**Public Comment No. 1394-NFPA 70-2021 [Global Input]**

Committee: NEC-P10

Committee Statement

Figure 2: Test Apparatus in Ceiling Configuration

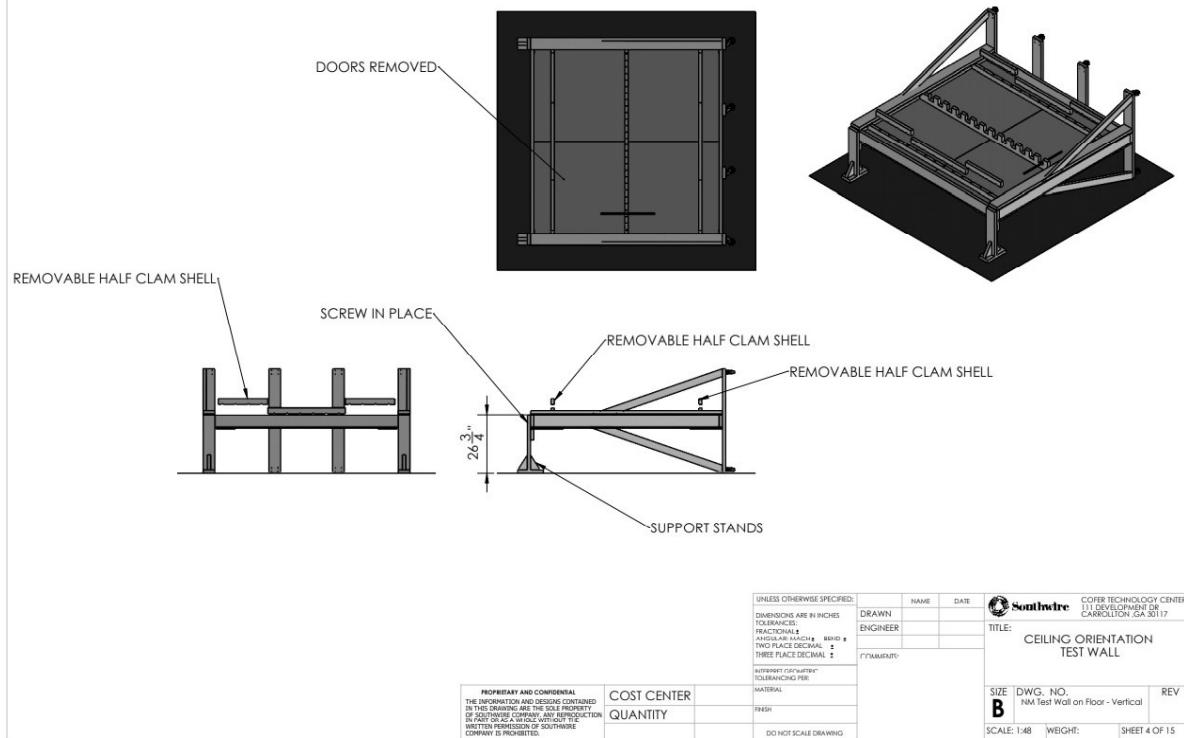
The temperature on multiple channels on Figure 2 exceeded the limit of the data logger after approximately 26 minutes. The test lasted for 47 minutes before it was decided to stop testing. The maximum temperature recorded was 102°C above ambient.

Figure 1

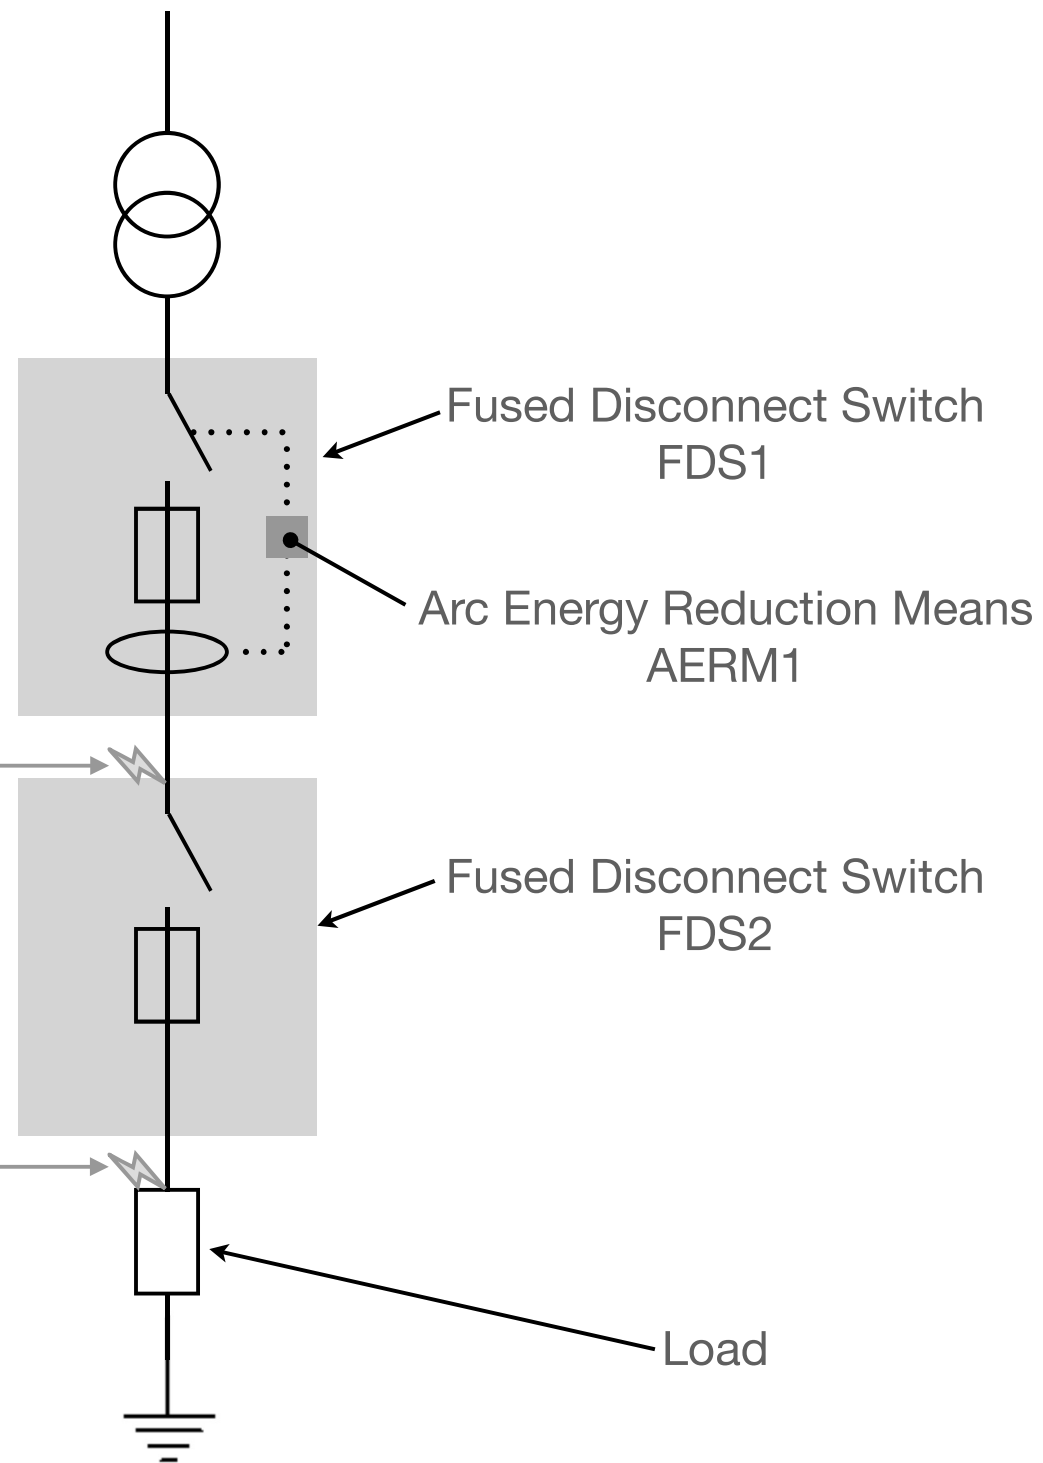
An example is provided to illustrate how this proposal would impact installations. Referring to Figure 1 (Attachment to PC) and making the following assumptions:

Committee Action: Rejected

Resolution: The suggested language does not recognize that some technologies required as part of this section of the NEC do not respond to downstream events as they are outside of the zone of protection. The suggested exception would remove a layer of arc reduction technology without justification. In addition, the proposed language implies that the available arcing current is related to the downstream device which is incorrect. Arcing current is not driven by a downstream device. It is driven by characteristics of the equipment including bus distances, voltage levels, and bus configurations to name a few parameters important to determining arcing current when IEEE 1584-2018 is used. This new language would cause confusion in the application of this section.

Figure 2

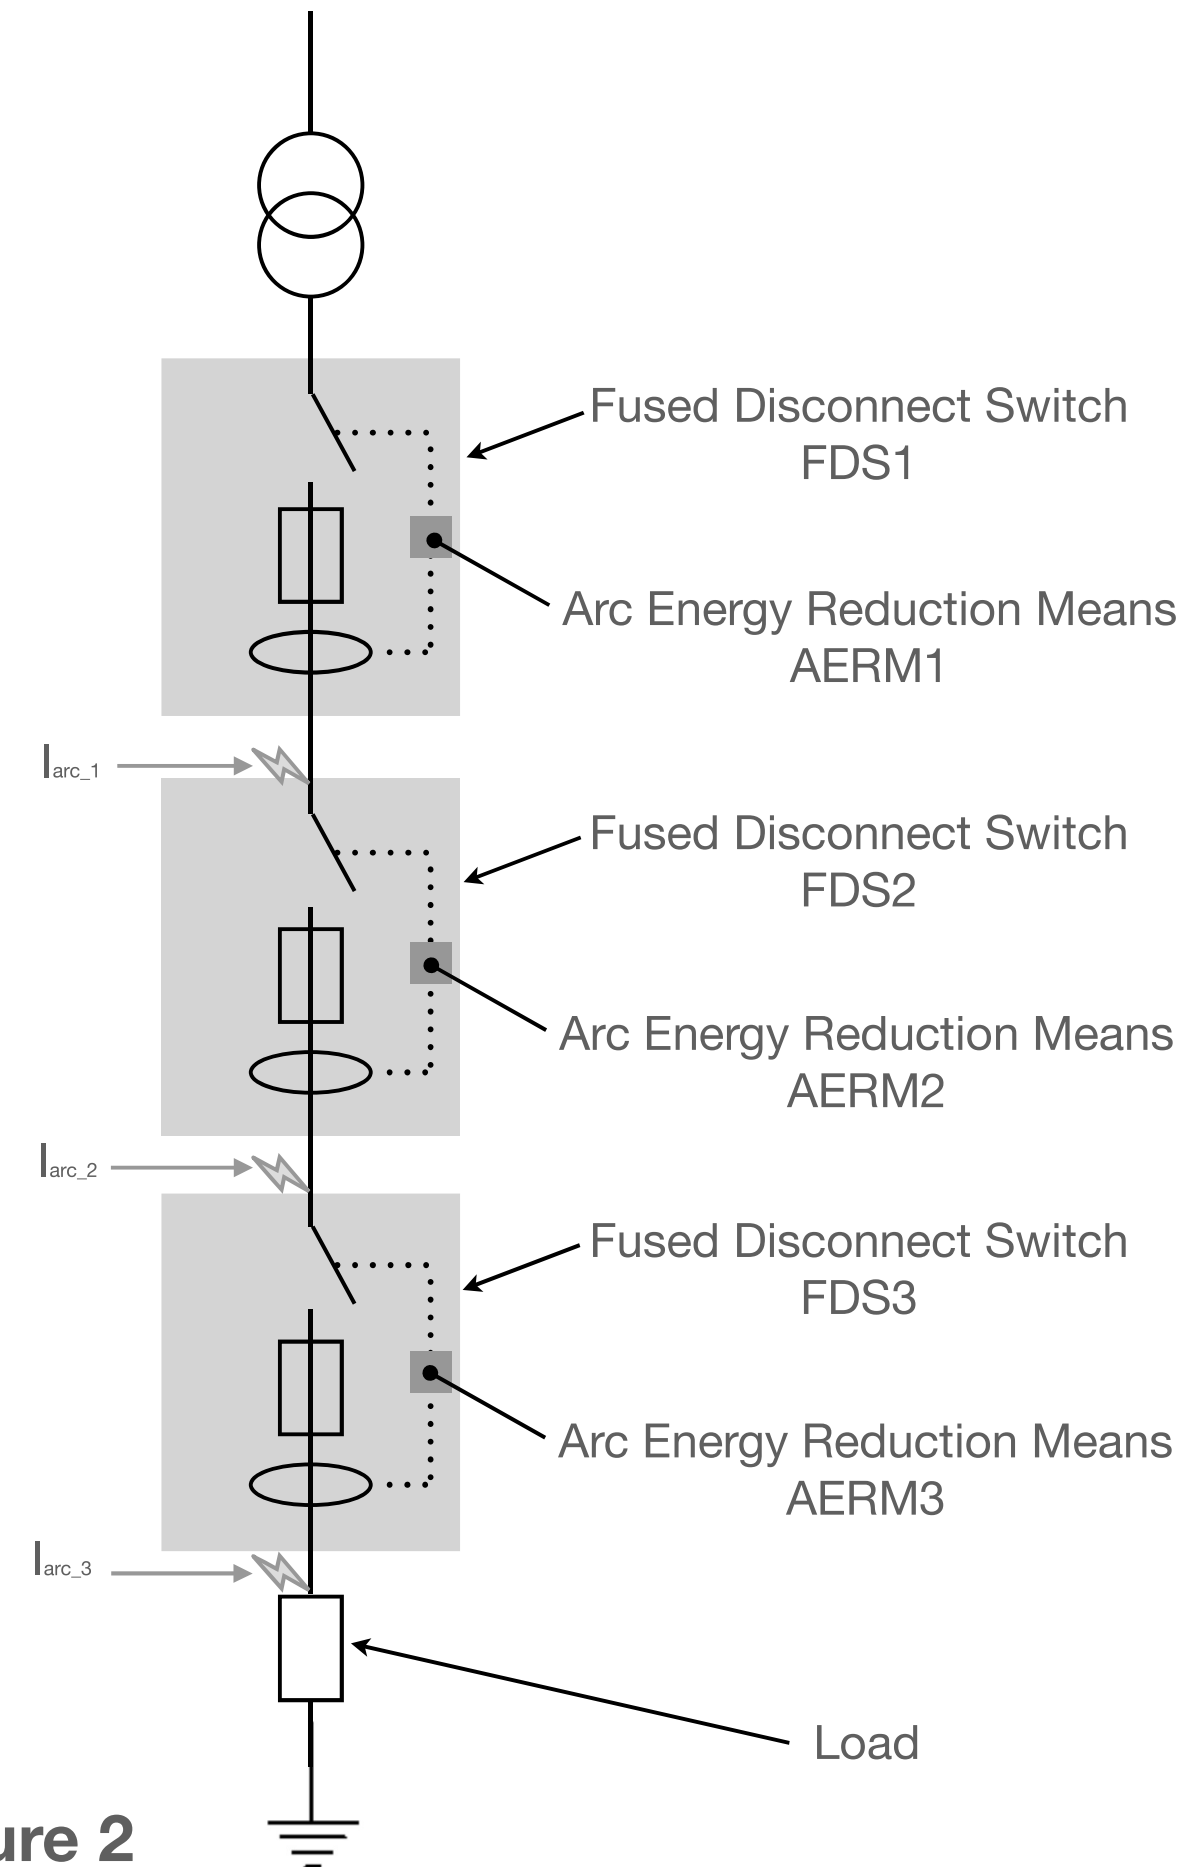
This logic follows as OCPDs are added farther downstream from FDS1. For example, if a third disconnect switch is added, as illustrated in Figure 2 (Attachment to PC), the associated OCPD is rated at $\geq 1000A$ and AERM3 is installed and set to $I_{aerm3} < I_{arc_3}$. If Case 2 applies to FSD 1 and FSD 2, the following additional cases arise:
